Addendum #1 - Issued September 21, 2012

Regarding Bids for **Pre-Engineered Metal Building System (ITB 12-026P)** for Lucas County Engineer Road Maintenance, bid opening scheduled for October 4, 2012.

ADDENDUM NO. 01

**Lucas County Road Maintenance Building
Pre-engineered Metal Building System – Bid Package 12-
026P**

SHEET TITLE
Exterior Elevations

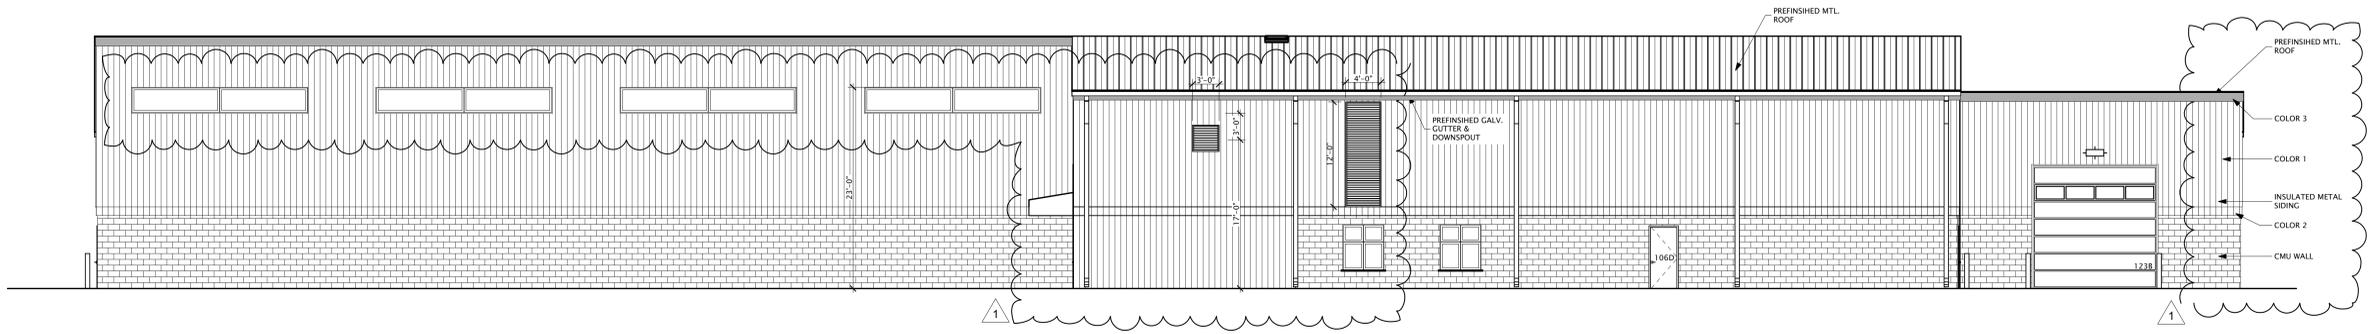
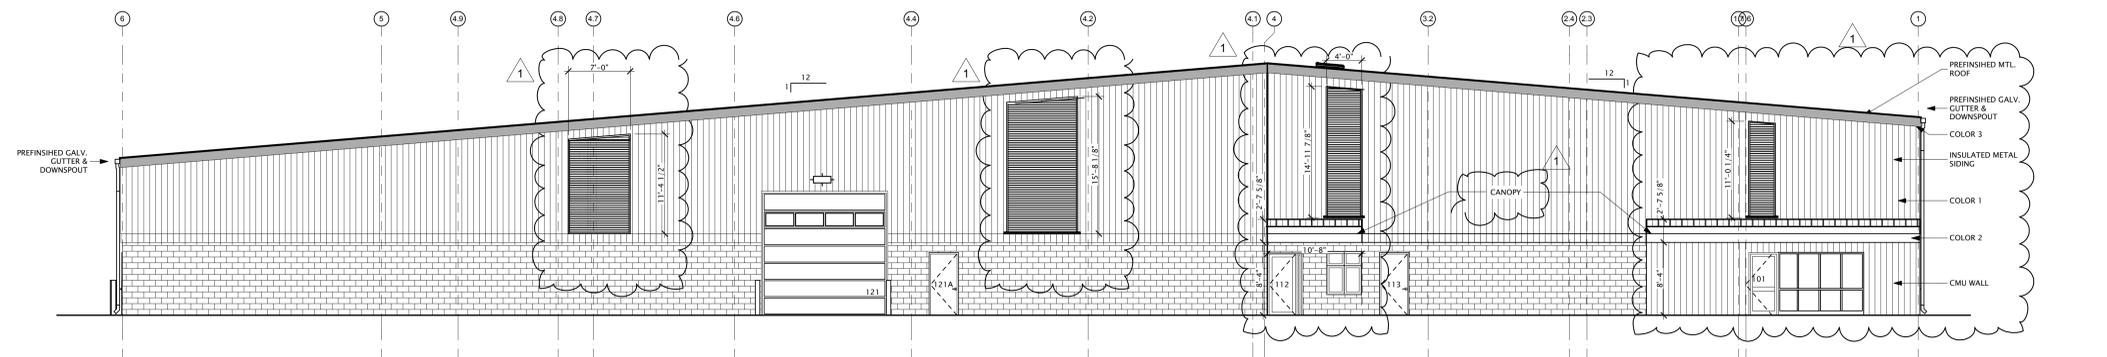
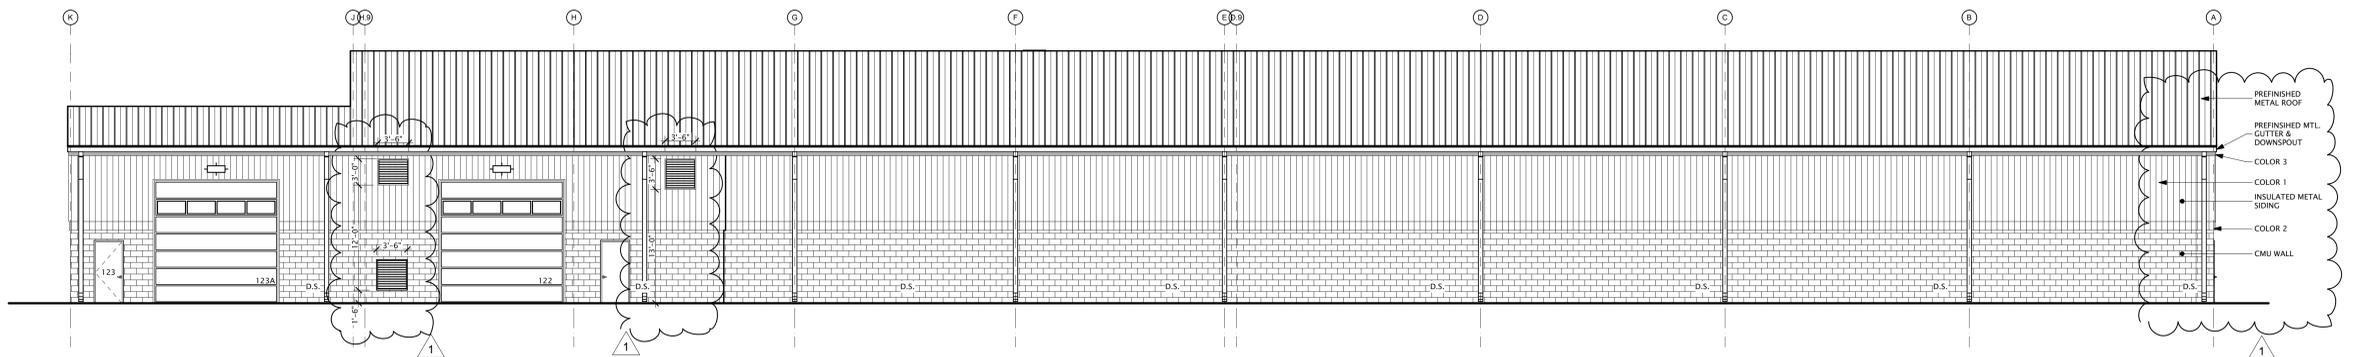
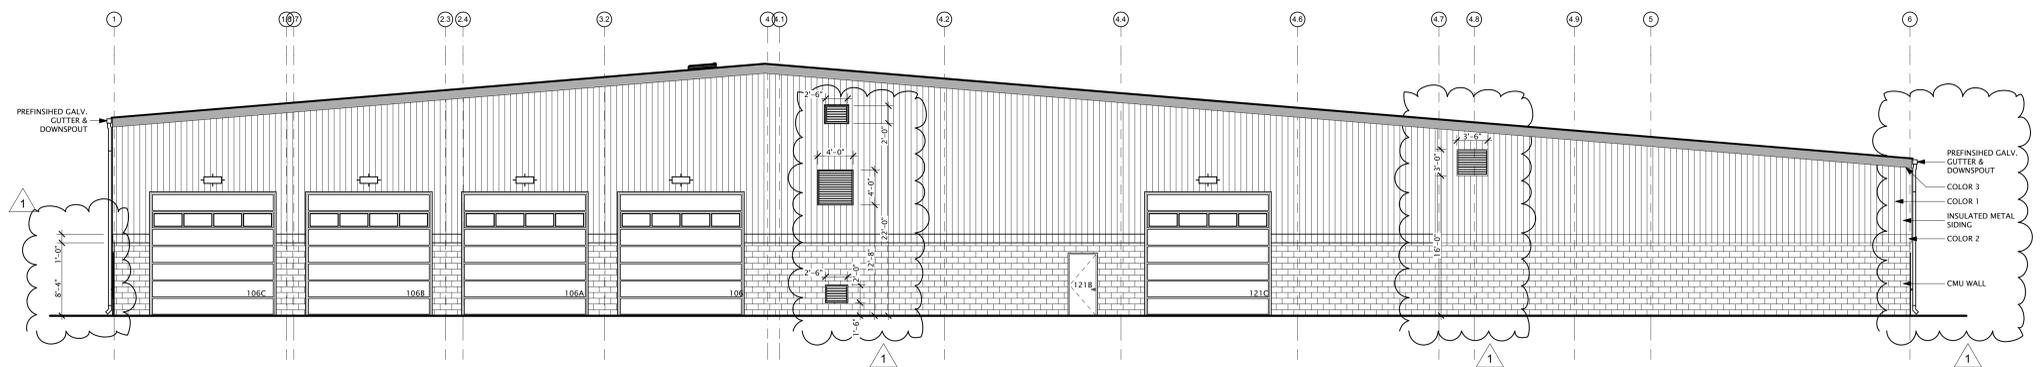
ALL LOUVERS PROVIDED BY PEB CONTRACTOR

ALL LOUVERS PROVIDED BY PEB CONTRACTOR

ALL LOUVERS PROVIDED BY PEB CONTRACTOR

ALL LOUVERS PROVIDED BY PEB CONTRACTOR

- Item #1 Added high windows on South Elevation.
- Item #2 Added louvers on South Elevation.
- Item #3 Extended insulated metal siding to grade in specific areas along South Elevation.
- Item #4 Eliminated two (2) punch windows on South Elevation.
- Item #5 Added louvers along the West Elevation.
- Item #6 Extended insulated metal siding to grade in specific areas along West Elevation.
- Item #7 Revised entry door to storefront system on West Elevation.
- Item #8 Added two (2) canopy structures above doors on West Elevation.
- Item #9 Added louvers on North Elevation.
- Item #10 Added louvers on East Elevation.
